This depiction illustrates the revisions to the line between Lots 95 and 96 as per the revised plat recorded in Plat Book 47, Page 117.

Title:	Date: 09-10-2009
File: Revisions to Lots 95 and 96, Steele Forest Subdivision - Henry County.des

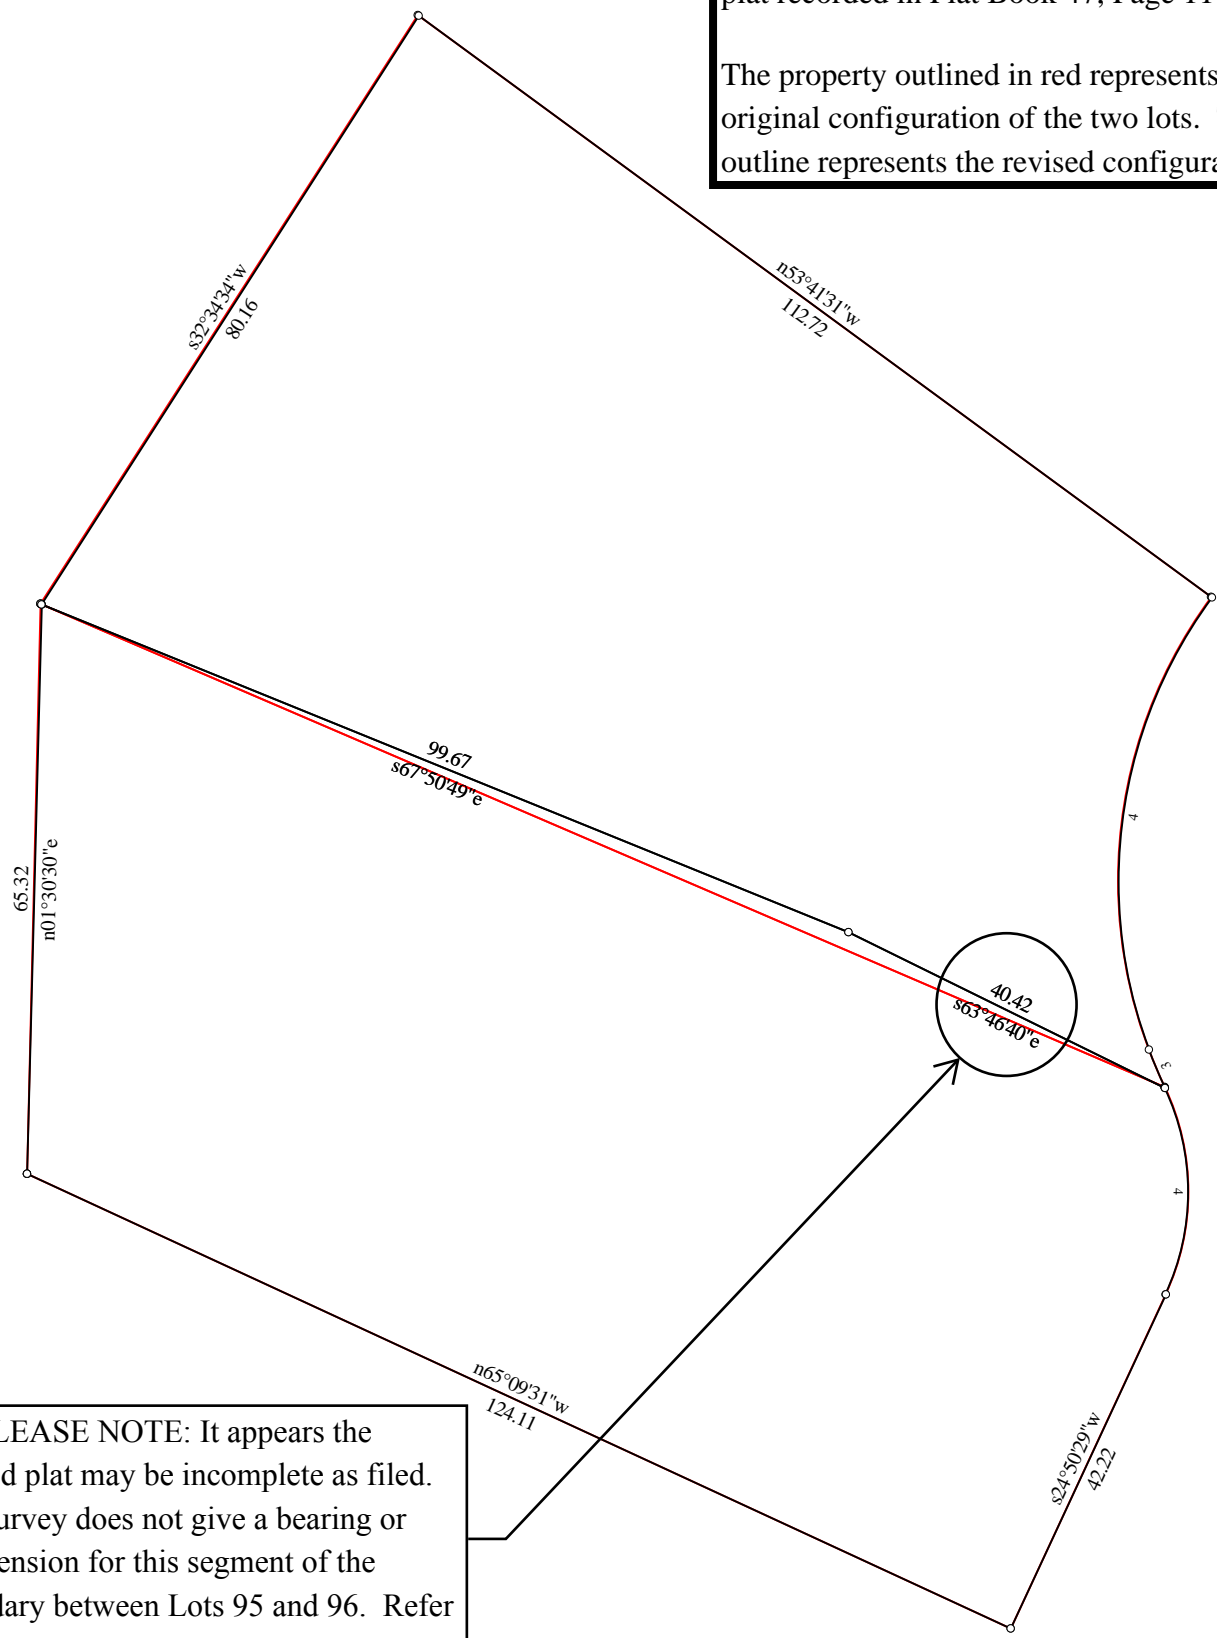
The property outlined in red represents the original configuration of the two lots. The black outline represents the revised configuration.

\*\*\*PLEASE NOTE: It appears the revised plat may be incomplete as filed. The survey does not give a bearing or a dimension for this segment of the boundary between Lots 95 and 96. Refer to title notes.

014=s63.4640e 40.42 ? - This call is not provided by the survey, it had to be generated by the mapping program.

020=s63.4640e 40.42 ? - This call is not provided by the survey, it had to be generated by the mapping program.
